Maids Moreton & Foscote Action Group
c/o Foscote Manor
Foscott
Buckingham
MK18 6AE

PL/25/5939/CONDA
Discharge of Condition 5

We have written to you and Mr Raven's predecessor – Tim Thurley - on many occasions about the safety issues with the proposed mini roundabout at the Main Street/Walnut Drive junction, which were raised in the Stage 1 RSA but have not been addressed.

Diagram 1a

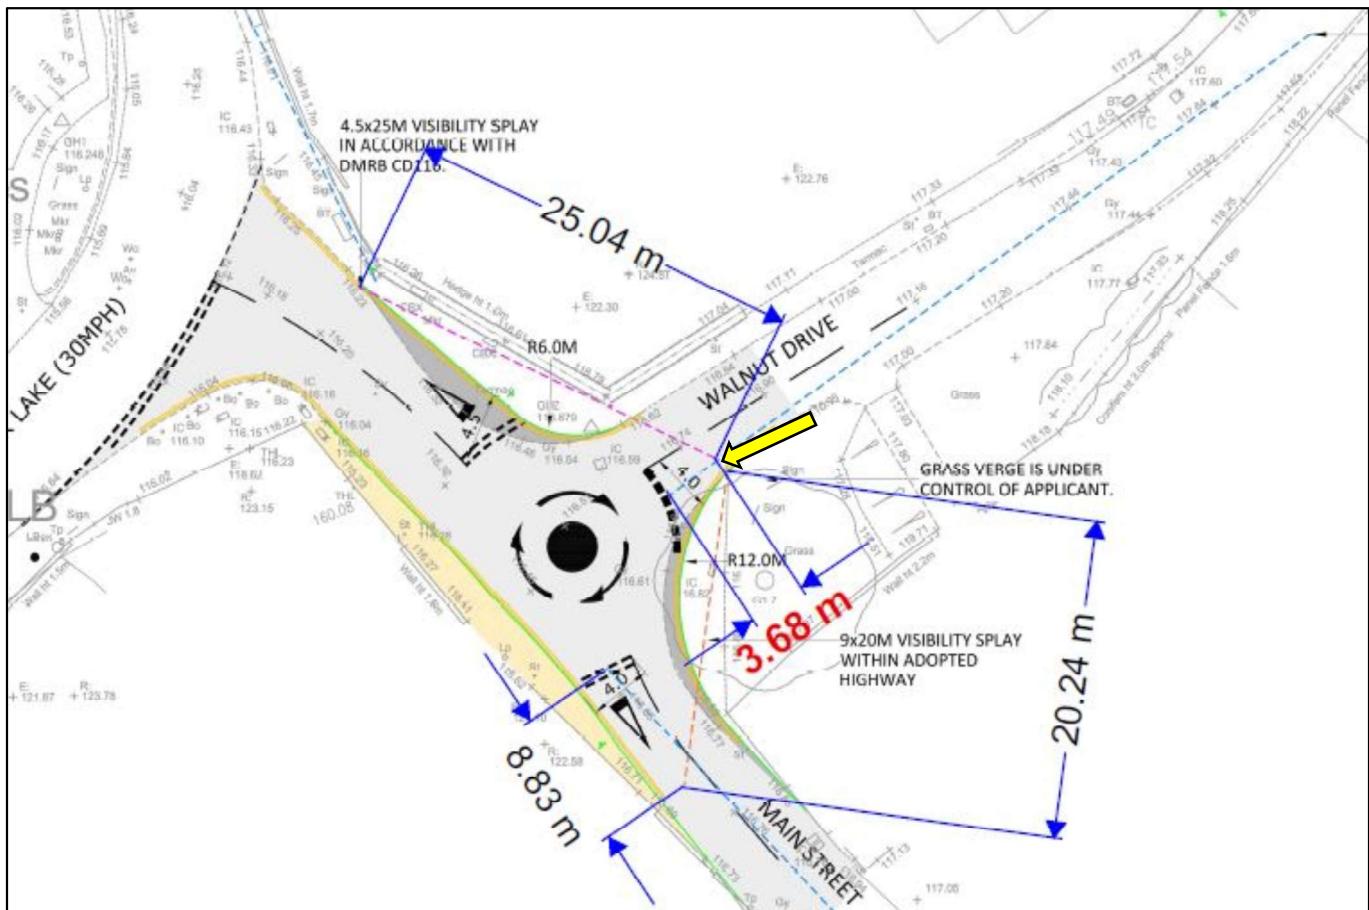
- 2.2 The visibility splay on the Walnut Drive approach has been compromised by the Applicant (see Appendix II, Diagram 1a) in two ways: -
 - i. DWH has surreptitiously reduced the **F** distance to **3.68m**, despite being labelled as 4.5m. The Applicant has submitted a scaled drawing so it is easy to measure. Now this has been drawn to your attention we trust **you will now verify this** for yourselves using the fully scaled, geometrically correct CAD data; and
 - ii. DWH has shifted the visibility splay to the centre of the passenger side on Walnut Drive, instead of taking it from the centre of the offside approach (ie the driver's side).
- 2.3 When measured correctly from the centre of the offside approach lane (the driver's side) and with the correct **F** distance of 4.5m, the visibility splay (the **D** distance) on the Walnut Drive approach is in

3.1 The visibility splay (the **D** distance) from Main Street (South) has also been arbitrarily reduced from 25m to **20m** (marked up by the Applicant in Appendix II, Diagram 1a). Whilst the **F** distance can be reduced from 9m to 4.5m, there is **no authority** to reduce the visibility splay itself (the **D** distance) to **20m**, nor is there any road safety study to underpin this compromise. No justification of this reduction by the Applicant or Buckinghamshire Highways has been provided, and no safety risk assessment has been carried out.

The visibility splay 'D' from Walnut Drive is **incorrectly** measured from the centre of the passenger side of the Walnut Drive carriageway instead of the centre of the off-side approach lane (ie the driver's side), **3.68m** from the give-way line instead of 4.5m.

Diagram 1b

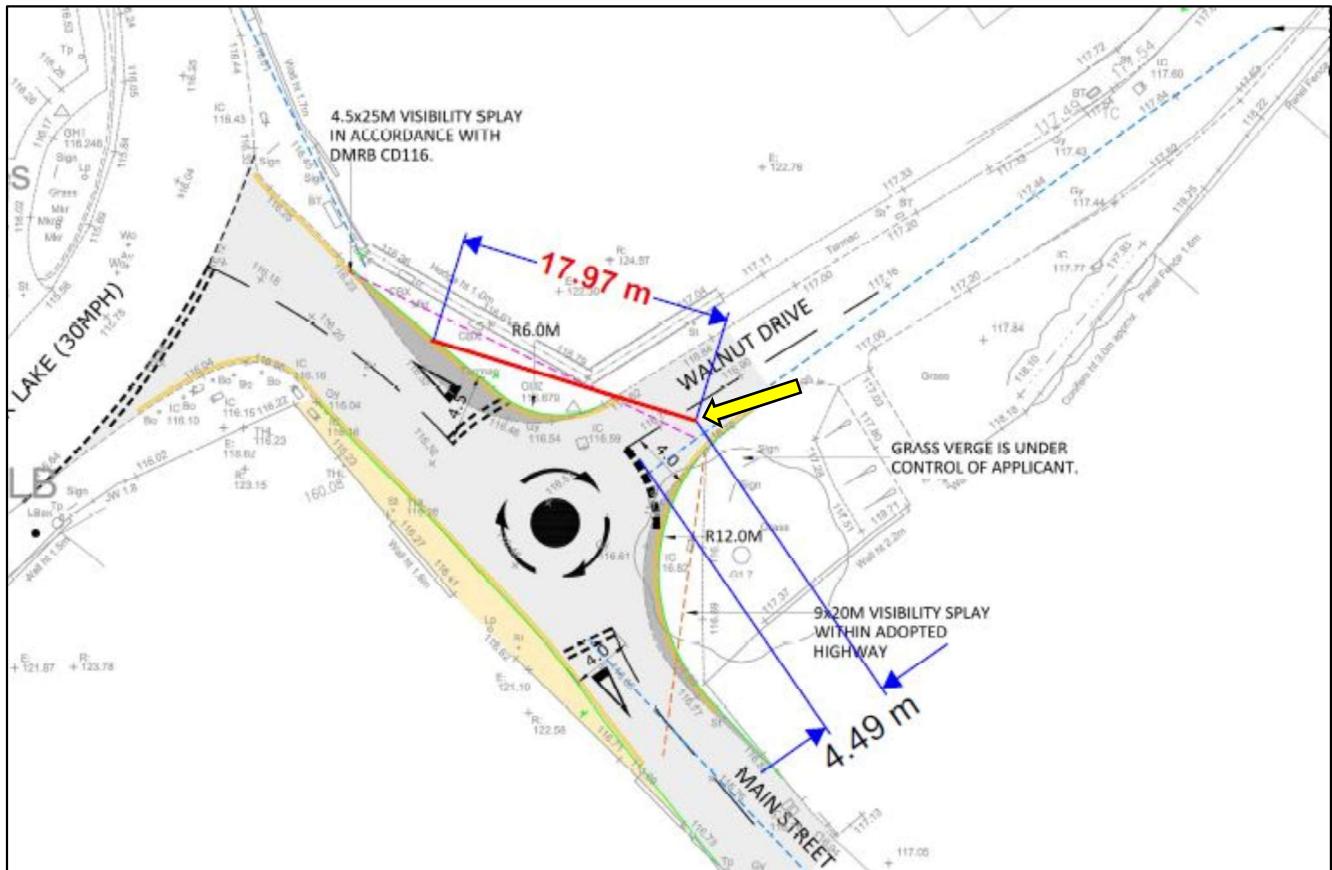
fact only **17.97m** (Appendix II, Diagram 1b), which falls **over 7m below** accepted safety standards and would be a **major hazard** to other road users.

When the visibility splay 'D' is **correctly** measured from the centre of the off-side approach lane, 4.5m from the give way line, the visibility splay is only **17.97m**.

Diagram 2a

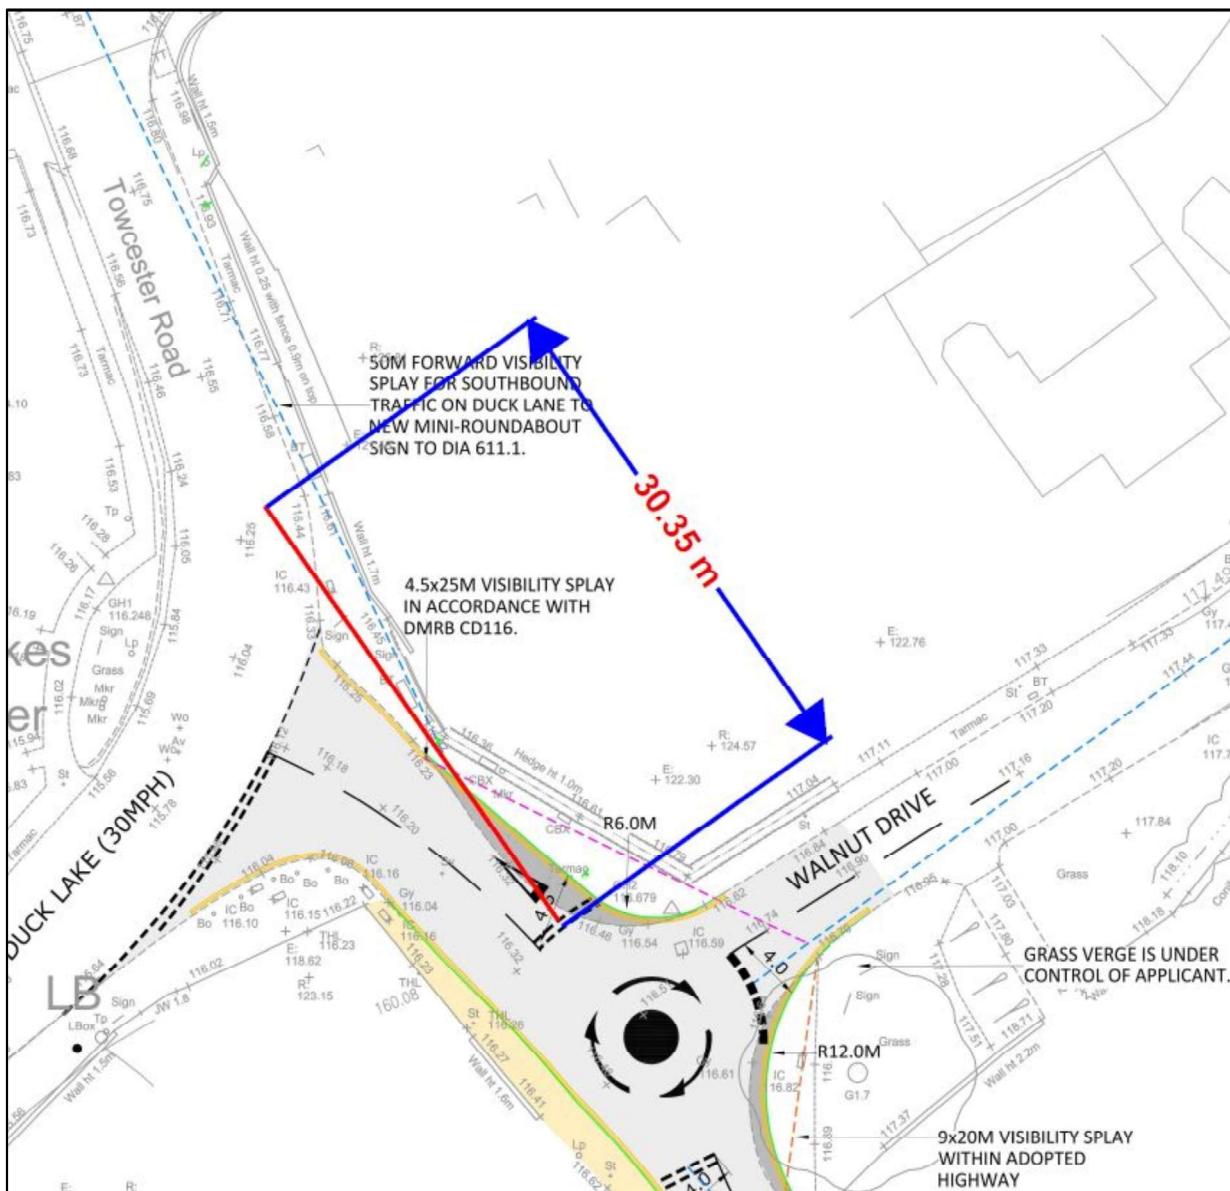
4.1 The required distance to the Give Way line from which oncoming vehicles will be able to see any road user entering the roundabout (the Stopping Sight Distance or **SSD**) is 50m. However, on the Main Street (North) approach the **SSD** is only **30.36m** (see Diagram 2a). This is 20m less than the minimum acceptable distance required by CD116. There is no authority or safety risk assessment to justify measuring the **SSD** from the roundabout sign.

When correctly measured to **the give way line**, instead of mini-roundabout sign, in order to avoid non-highway land, the SSD 'E' is reduced to **30.35m** for vehicles approaching from Akeley/Towcester.
